Firmware 1.8.2

Firmware 1.8.0

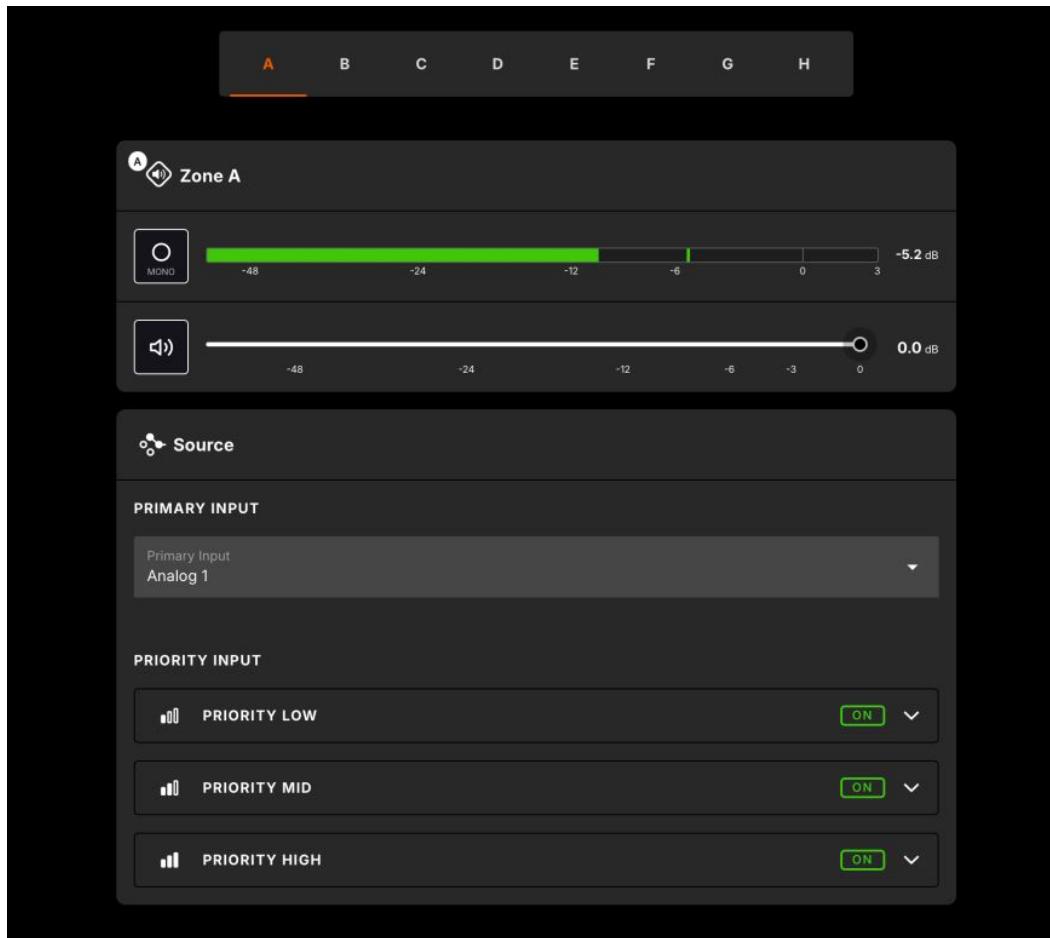
- **Two additional priority input levels per zone.**

- This update adds two extra priority input levels per zone, expanding system flexibility.

The new priorities include:

- Threshold control
- Zone volume override
- Hold time functionality

- Example setup – retail environment:
 - Primary input: Background music
 - Priority Low (overrides primary input): Commercials
 - Priority Mid (overrides primary and low input): Microphone announcements
 - Priority High (overrides all): Voice alarms

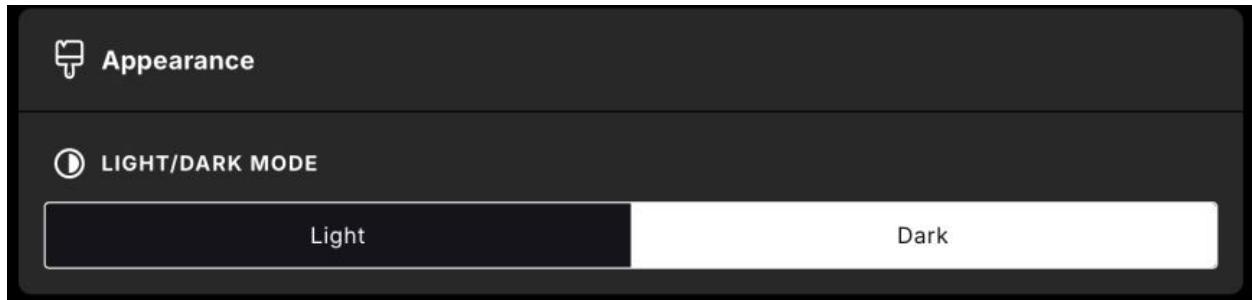
- **Dark mode is now the default appearance setting.**

- A new “Appearance” tab under Settings lets users switch between Light and Dark mode. This setting applies only to the selected amplifier and does not affect the PowerZone™ Control Center interface

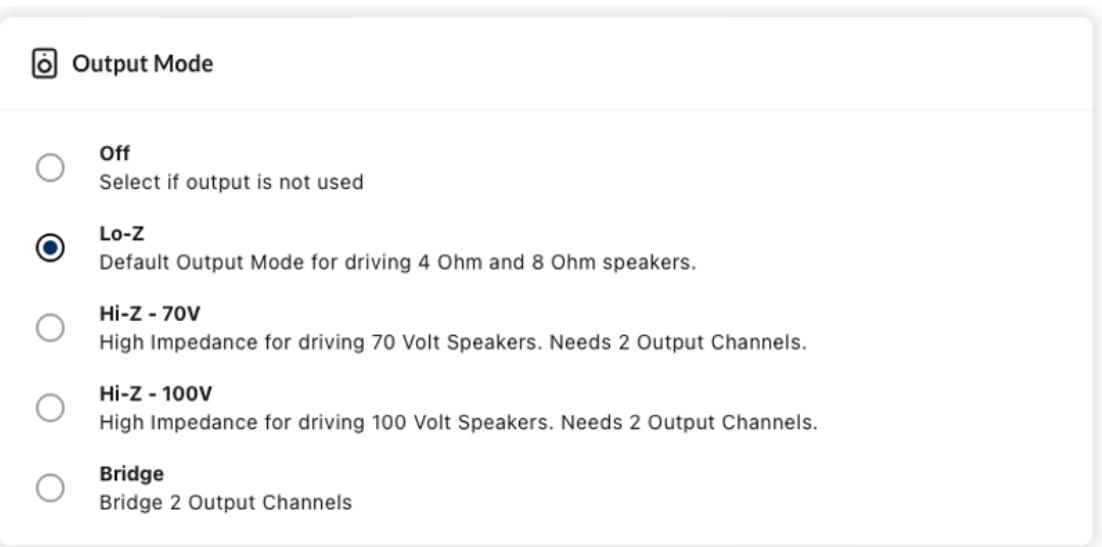
- Enabling BTL mode / Bridge mode on 1U units.
 - This has always been enabled for 2U units, but it is now enabled on 1U units as well, so the installer can bridge two output channels together.

Area 1 – Button arrangement (EQ)

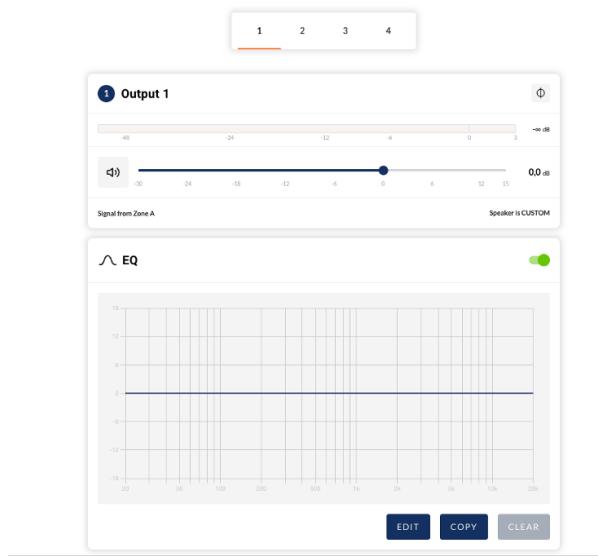
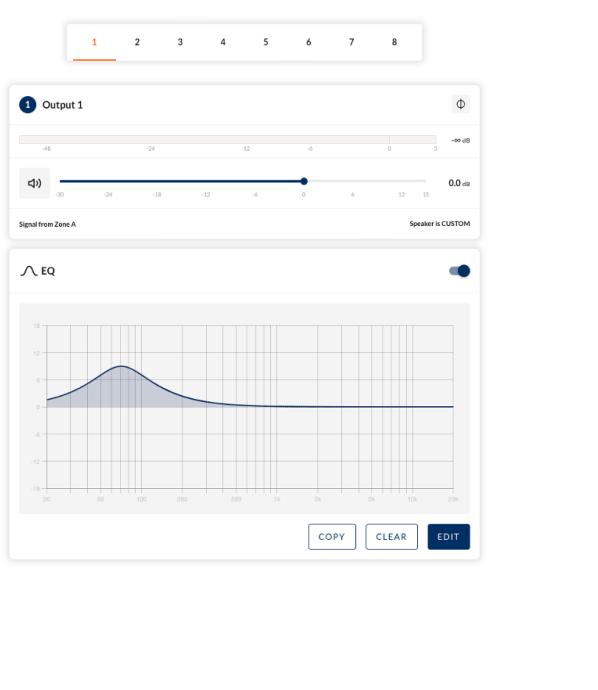
Primary buttons are placed towards the right, while the secondary buttons from left to right.

Area 4 – Secondary buttons e.g., “Reset” is outlined

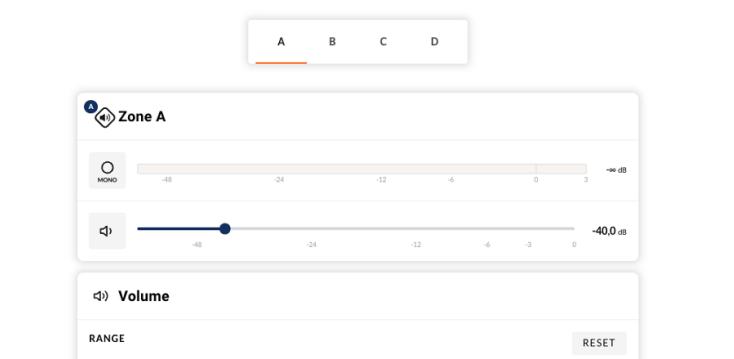
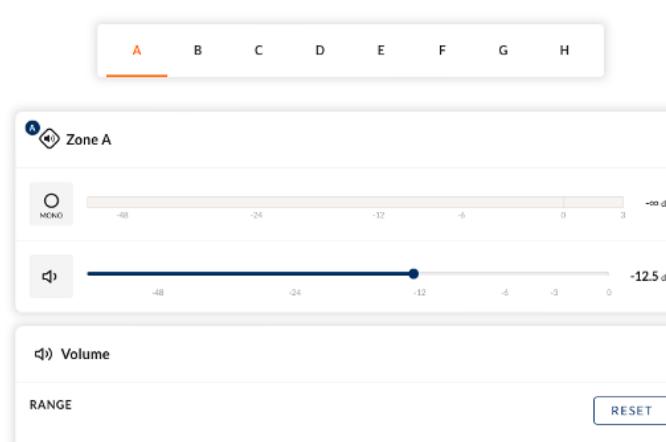
This goes throughout the entire GUI, so all secondary buttons are marked with an outer line.
